Subject: **Bid #: 8319-W5, Lincoln Square Improvements / DPWP**

ADDENDUM NO. 3

Date: November 21, 2024
Project: Lincoln Square Improvements
City of Worcester Department of Public Works and Parks
Parks, Recreation and Cemetery Division

General Bid Clarifications

24" x 36" x 36"
Pull Box

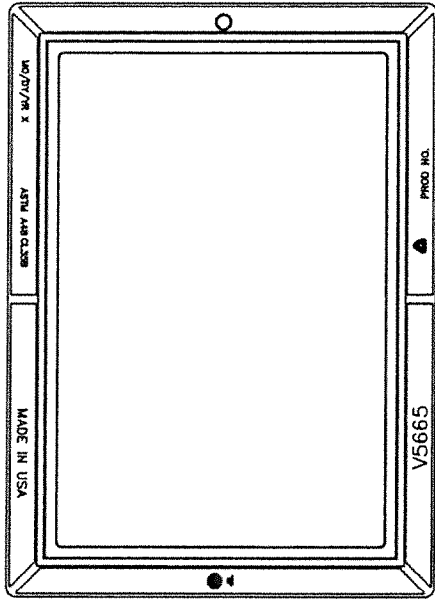
- a. **Yes, See Article 39**
9. The Typical Handhole Pullbox Detail shown on drawing E2.1 is excessively oversized, particularly for the electrical system. Can the handhole size be reduced, as long as it is in compliance with the electrical code?

- a. **Revised Project Standard Handholes and sizes attached.**
10. Is the City of Worcester responsible for payment of National Grid and Telephone Company charges for new electrical and fiber optic services?

Project Standard Handholes/pullbox - 24" x 36" for communication and 12" x 24" for electric. (6 pages)

ASSEMBLY SUBMITTAL SPEC SHEET

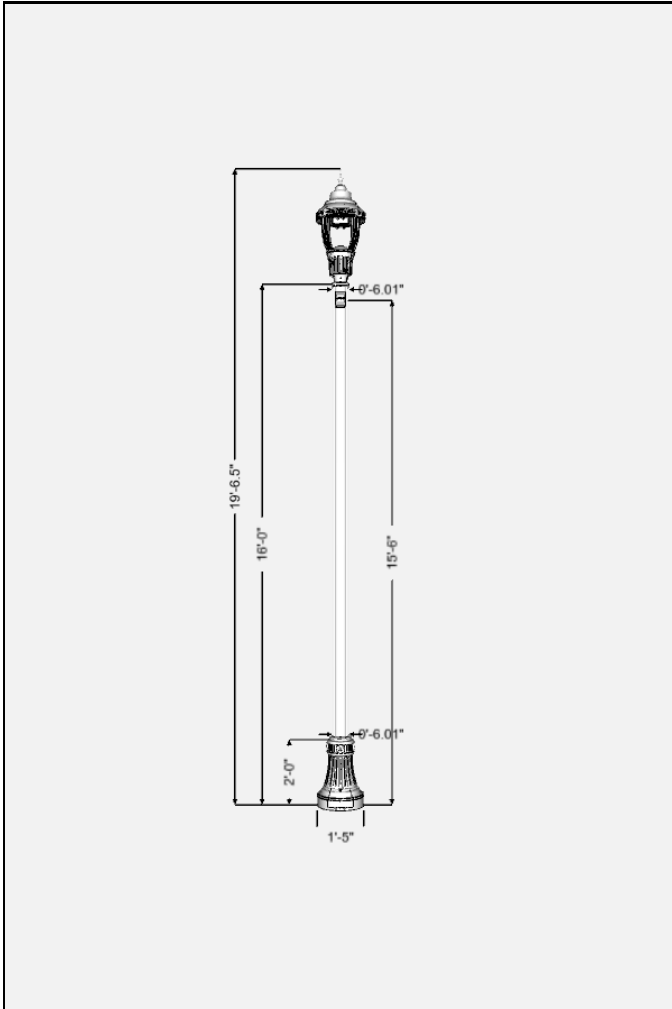
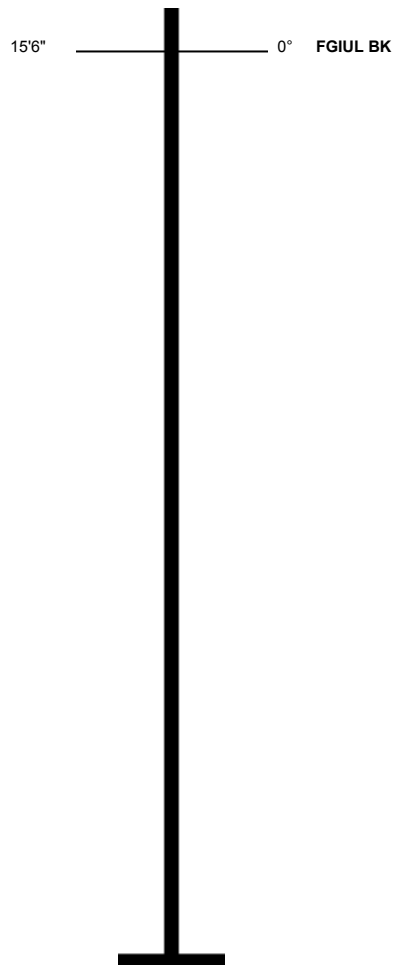
- a. **No, it is not required.**
2. Please see lighting fixture schedule on drawing E0.1. Under the "Remarks" column of the type SL1 light pole, there is mention of types SL2 and SL3 light fixtures. What are these fixtures? It is our understanding that type SL1 lighting has one light fixture, not three.

- a. **Yes, just one style light fixture. Please disregard all references to SL2 and SL3. Revised Project Standard for light fixture SL1 and pole, attached. Furnish and install two auxiliary electrical exits per pole.**

Project Standard Light fixture and pole Type SL1 (9 pages)
